TECH Information

Date: : 2009/10/16

Object: : CNC Billet Throttle

Pic-1

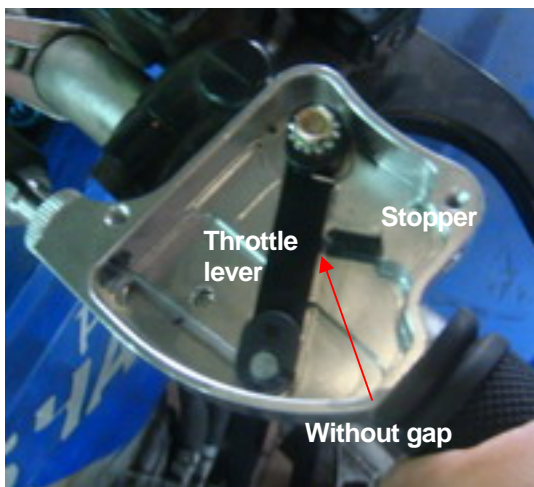
Due to some of users advise the operation of CNC billet throttle is too tight and some of throttle lever are broken. Please kindly follow the items to tune and adjust the CNC billet throttle.

1. Spring of carburetor (pic-1), if user still thinks the softer spring is not easy to operate then cut off 20~30mm then the operation of throttle will be not tight as well.
2. Adjust the gap between throttle lever and stopper, **make sure the gap will be "ZERO"** by stopper when the throttle is whole open as the pic-2. Pic-3 shows the gap when the throttle is whole open, the lever will be twist then bent and broken by force.
